Re: AMENDED PART 573 NOTICE RE RICON WHEELCHAIR LIFT
NHTSA # 10V-087

Safety Defect and Noncompliance Report Guide for Vehicles
PART 573 Defect and Noncompliance Report

MCI Service Bulletin 341B

Current Lock Mechanism

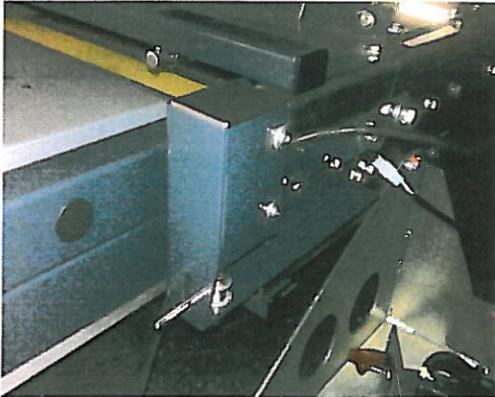
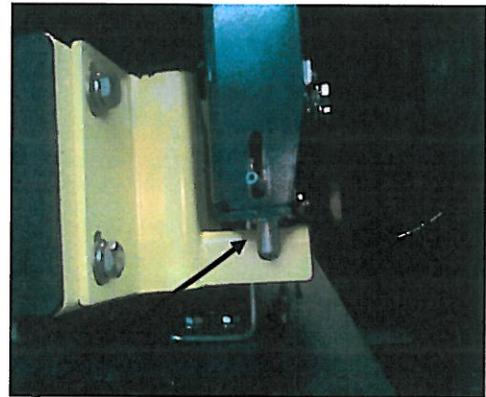
MCI has become aware of instances in which the Ricon WCL experiences a failure of the roll pin that Ricon designed to secure the primary drive chain sprocket to the intermediate shaft. If this occurs, the output driveshaft is no longer connected to the drive mechanism and the WCL can then move freely in or out of the structure due to the lack of a secondary locking mechanism in the Ricon WCL design.

If either of the two foregoing failure modes occur, the Ricon WCL may slide unrestrained on its rollers in the storage structure, potentially breaking through the cassette door and extending beyond the outside of the door when the coach is in motion, particularly when the coach is making a left turn.

MCI will provide the parts and labor to install, at no cost to customers, a Ricon-designed retrofit kit that includes a spring-loaded lock mechanism. The mechanism can be activated electrically or manually, but will always return to the "locked" position without power or without the operator holding it in the "unlocked" position. The additional lock mechanism will prevent unintended WCL deployments regardless of cause.

New Spring Loaded Lock.
